**Panel Report**

**Whitehorse Planning Scheme Amendment C175**

**Box Hill Metropolitan Activity Centre**

**6 October 2017**

**Figure 4: Extract of Character Precincts from Built Form Guidelines**

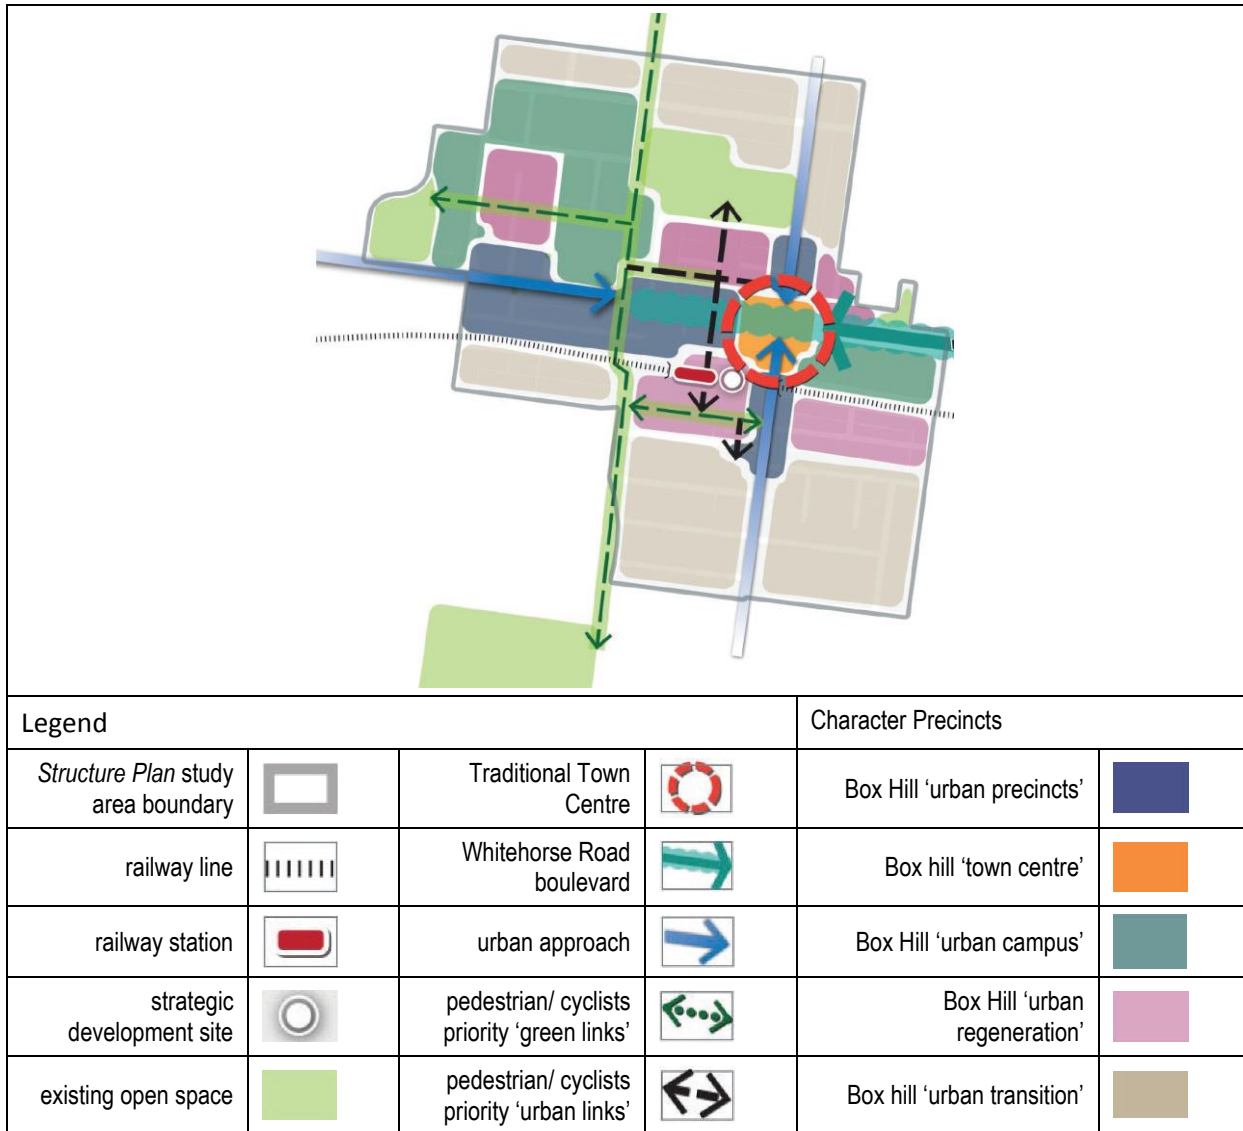
There is no clear relationship between the Character Precincts and the heights specified in the sub-precincts as shown in Figure 2; Table 4 shows the relationship between the character precincts and the sub-precincts that specify the built form controls.

**Figure 5: Cross-section with height limits (approximately only) in green – Whitehorse Road**

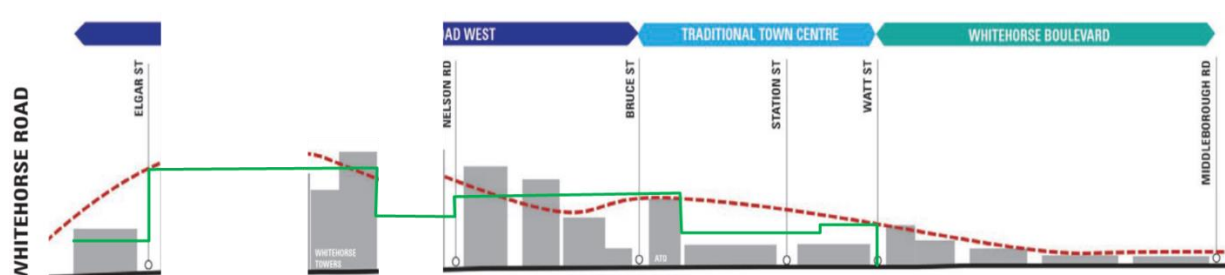
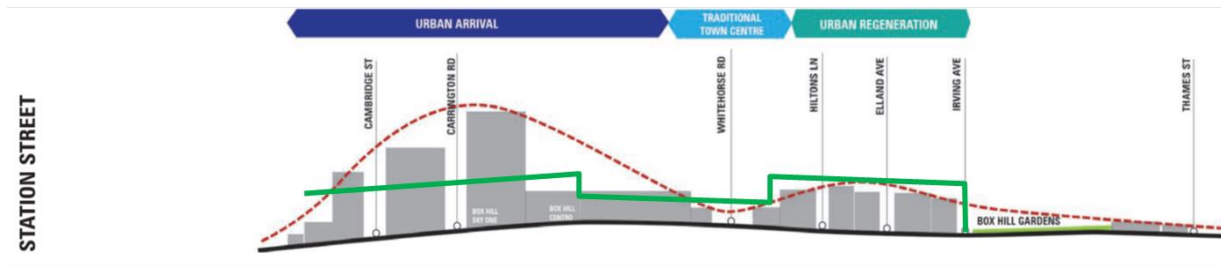
Comparing the proposed height limits to the cross-sections in the *Guidelines* reveals that:

"Limit maximum street wall to street width ratio to 2:1" gives a clear standard, but this is clearly not the complete explanation: Station Street has a 5 storey limit proposed in one section and a 10 storey limit in another, but appears to be roughly the same width throughout its length. It is not immediately clear that the streets in the sub-precinct F7 (10 storey street wall) are two and half times as wide as those in Box Hill Gardens (4 storey street wall), or twice as wide as Whitehorse Road in its widest part (5 storey street wall). This issue is discussed in more detail in section 6.6.3 of this Report.
